19-00042

From: [John Newberry](#)
To: [Elizabeth Rorie](#)
Subject: FW: Troubadour Club, Permit Application Submittal
Date: Monday, March 18, 2019 7:45:32 AM
Attachments: [image001.png](#)

Subject: **Modified NPDES Permit No. TN0027278**
Cartwright Creek, LLC - Grassland STP
Franklin, Williamson County, Tennessee

APPENDIX 1 WASTEWATER TREATMENT PLANT SCHEMATIC DIAGRAM

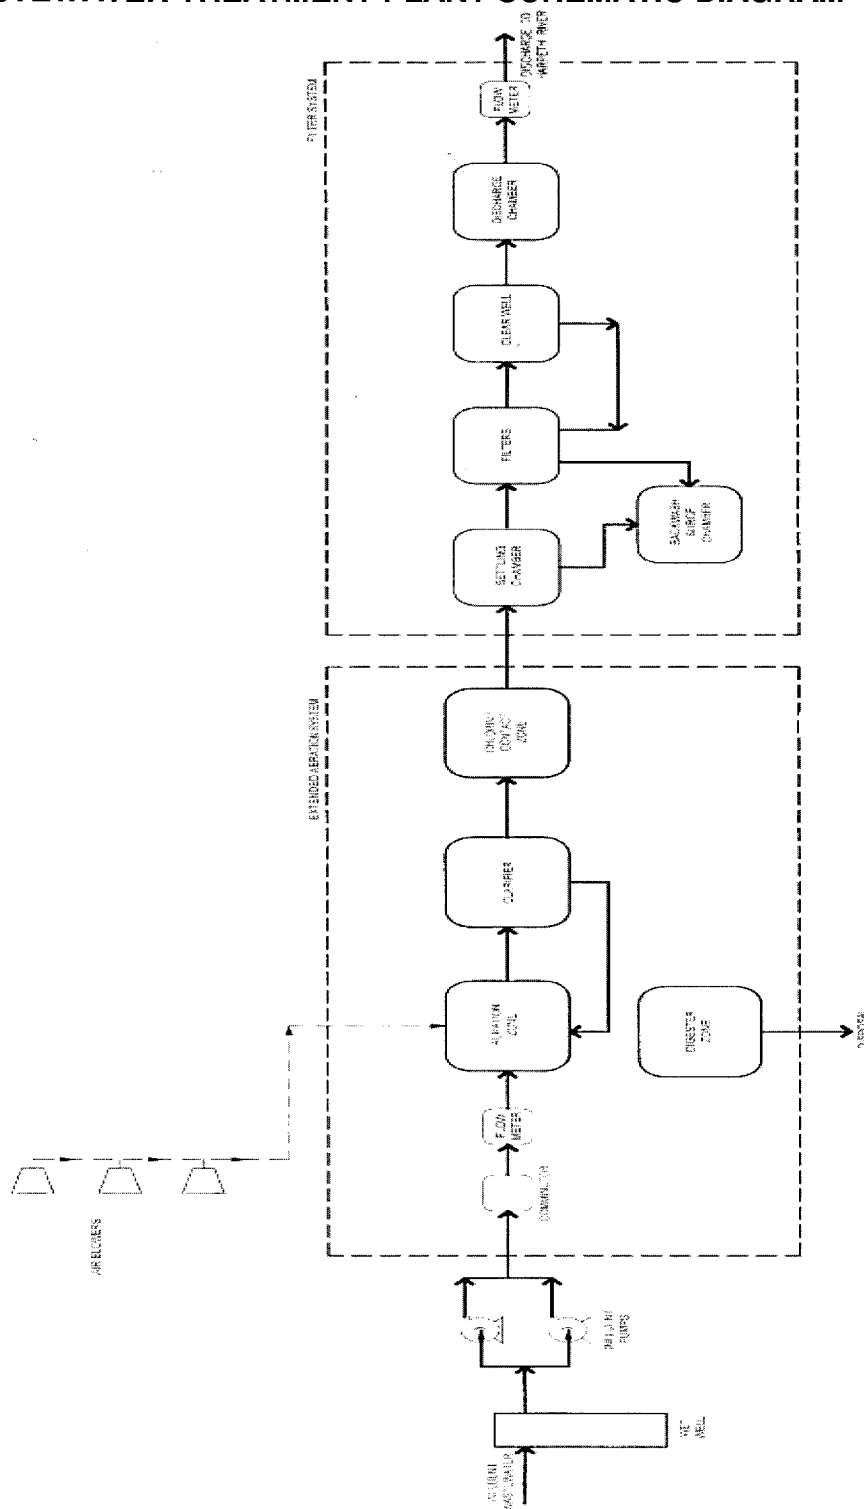
1. The process flow diagram (figure 2) needs (1)the anoxic recycle line shown;(2) the instrument and control elements added included flow rates. (The system could run entirely on level switches. I'm thinking a system this capable should us pH and DO at least, and even ORP, to operate efficiently.); (3) explain which parameters are remotely monitored; are there parameters which will cause an automatic shutdown? In the event of an emergency shutdown how will flow be diverted? (Answer to these question impact operator on-station frequency and attention.
